This gallery shows some pictures of bad solderings - they should prevent you from making the same errors (feel free to add even more pictures here!)

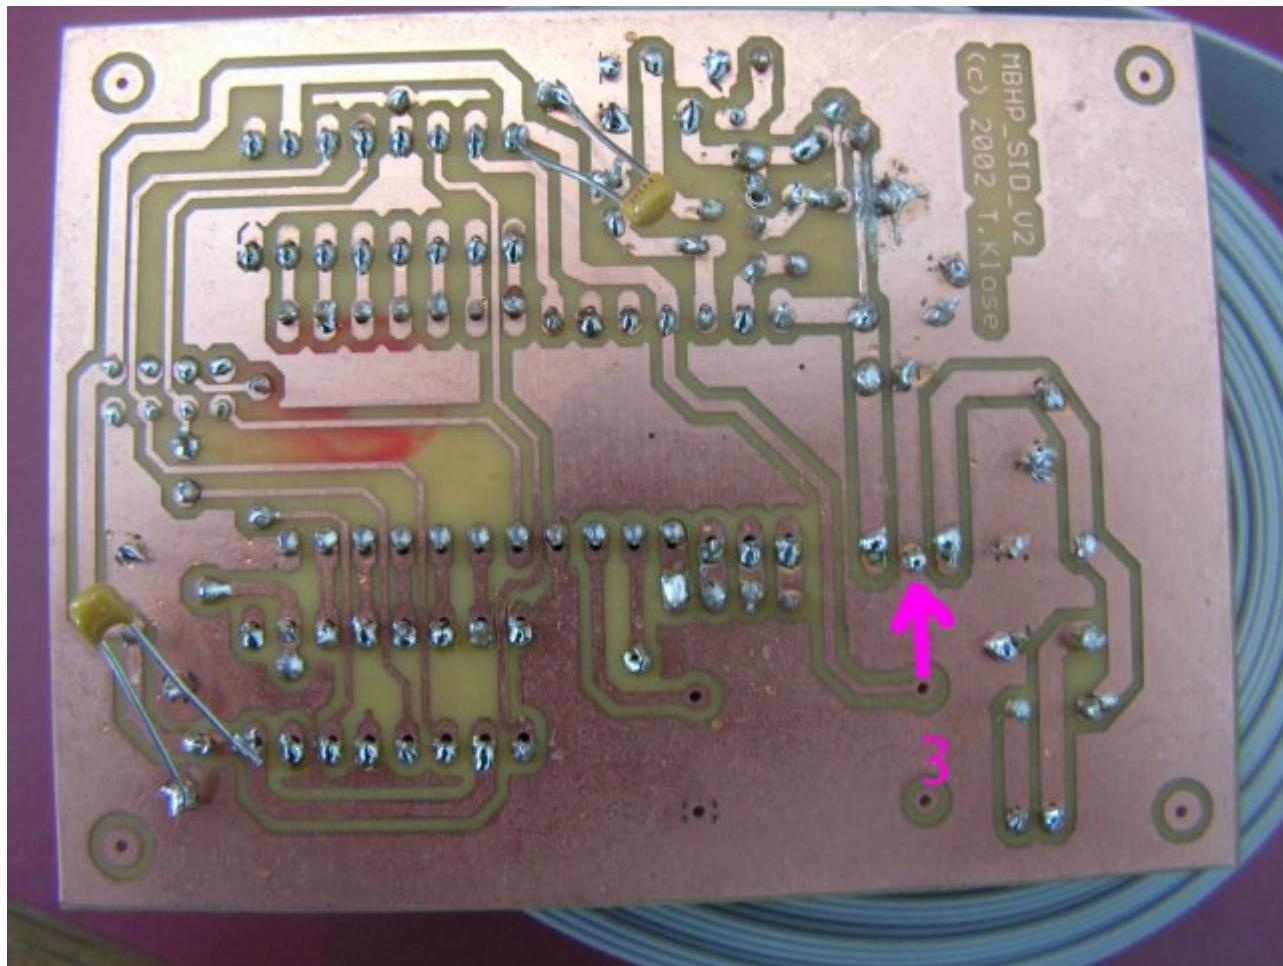
1: the core module has some bad solderings (loose connections), which could lead to failures. There are also missing solderings (e.g. 33pF cap below crystal). It makes sense to solder each pad again, the [Soldering](#) guide in the Wiki gives some useful tips

2: the legs of the caps should be cutted, otherwise they can cause a short circuit which can damage the PIC!

3: this seems to be a bad ground connection directly at the 78xx - it can lead to the wrong voltage. Here the same: just solder the pads again, it will help

And same like above: the long cap legs need to be cutted, the danger for shorts is too high!
